AN PART NO.
(e) ~~AN4139-1~~
AN4139-1A

PROCUREMENT SPECIFICATION	AIR FORCE-NAVY AERONAUTICAL STANDARD	AN4139
NONE	ADAPTER - TYPE XVI DRIVE FLANGE

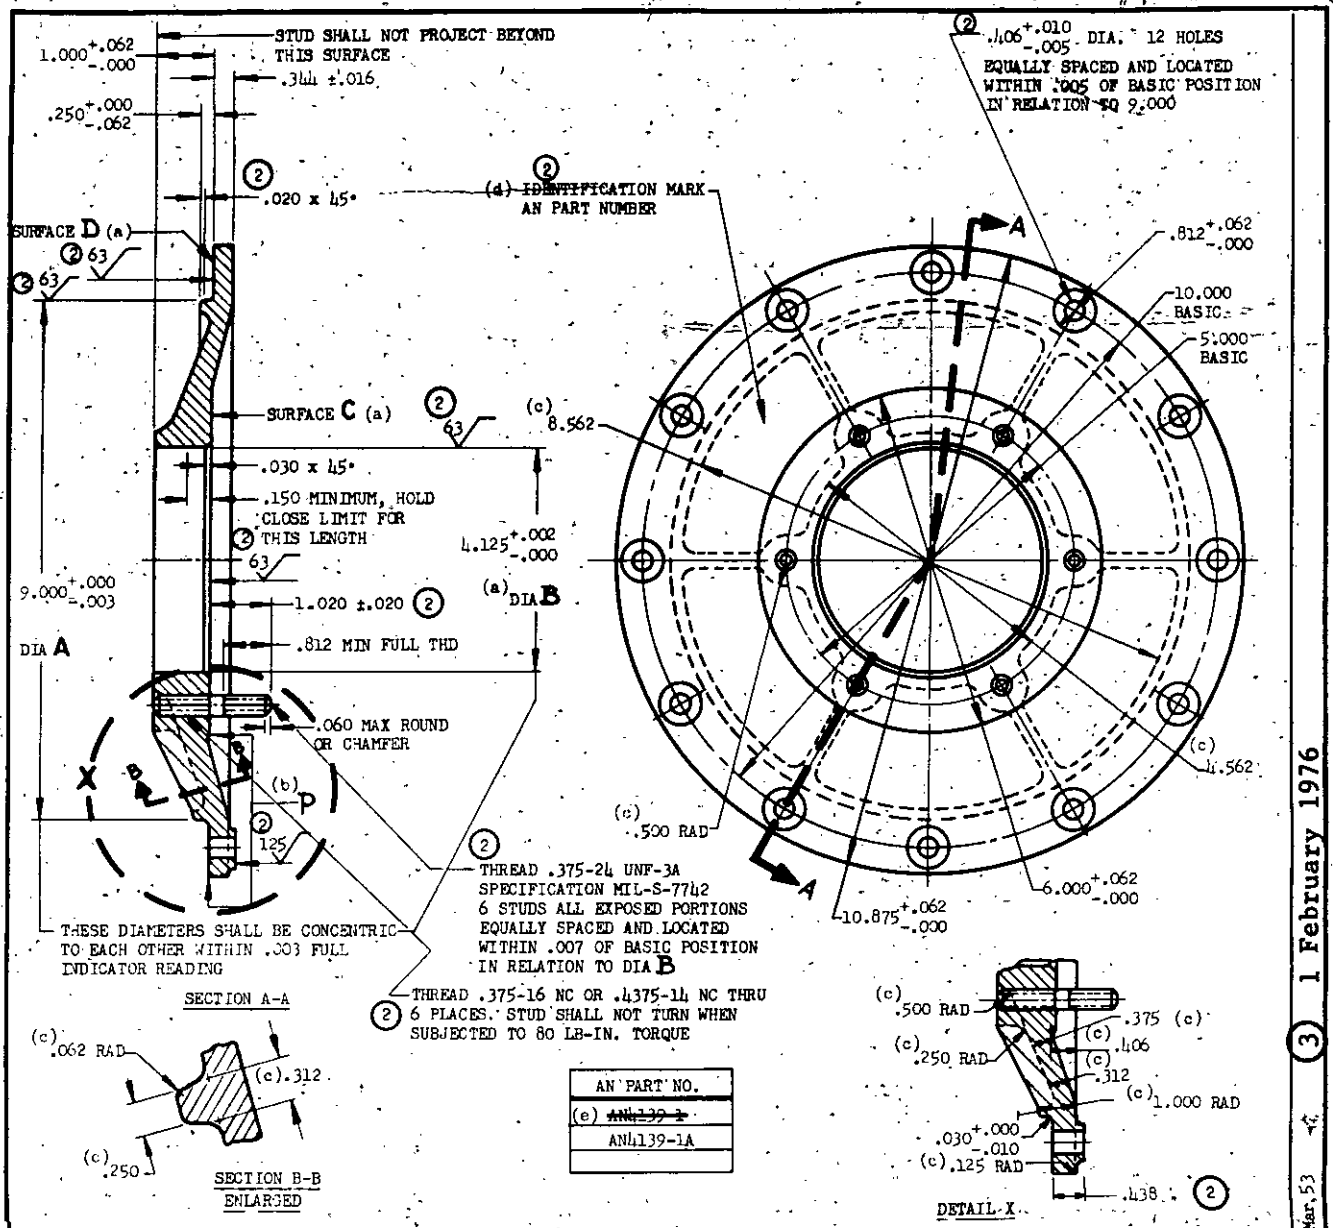
(e) PREVIOUS PART NUMBER AN4139-1 INACTIVE FOR DESIGN AFTER 12 AUG 1949. AN4139-1A REPLACES AND IS INTERCHANGEABLE WITH AN4139-1. FOR DEFINITION AND APPLICATION OF DRAWING STATUS NOTES, SEE ANA BULLETIN NO. 337.
STRENGTH: 6,000 DIA MOUNTING PAD SHALL BE CAPABLE OF WITHSTANDING A MAXIMUM OVERHUNG MOMENT OF 625 LB - IN. AND A MAX ACCESSORY WEIGHT OF 75 LBS.

(3) CANCELLED 1 February 1976 NO SUPERSEDING STANDARD
